HORSHAM DISTRICT COUNCIL CONSULTATION

TO:	Horsham District Council – Planning Dept
LOCATION:	Cedar Cottage Sandygate Lane Lower Beeding West Sussex
DESCRIPTION:	Demolition of existing dwelling and erection of 24no. dwellings including the creation of a new access from Sandygate Lane with associated works.
REFERENCE:	DC/26/0640
RE-CONSULT:	1 st set of comments in black 2 nd set of comments in blue
RECOMMENDATION:	Modification Modification

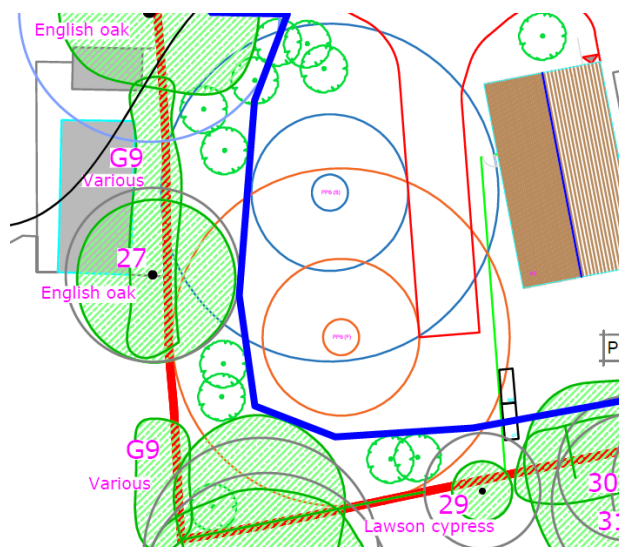
Further consideration should be given to the site layout, the access road in particular, in combination with the reduction of dwellings in order to have further regard for the retention and enhancement of mature trees on site which are key components of the receiving landscape.

2. It is also recommended that placing RPAs in private gardens is avoided where possible.
3. As the site is partially undeveloped, the layout can be adjusted to fully avoid RPAs. The alteration of the access road and the removal of the following dwellings is thus recommended:

- a. Plot 6 - within the RPA of T42, which benefits from a TPO.
Not addressed.
 - b. Plot 13 and the associated road - within the RPAs of T24 & T26.
The RPA of T24 has been avoided, with thanks. However, concern is raised regarding the proximity of the plot and the existing treeline, which is likely to result in a poor relationship and shading concerns. This places the trees at considerable risk of future lopping or felling pressure, which would further erode the site's landscape character and amenity value. Please amend.

- c. Plot 7 - within the RPA of 'notable' T19, which benefits from a TPO. While recognised that the current buffer zone is larger than the BS minimum requirements, the removal of this parcel will allow for the delivery of a more meaningful open space that can deliver on the amenity typology as per the requirements of Horsham District Council's Open Space, Sports & Recreation Review 2021 (OSSR). See point 7.
Not addressed; please amend.
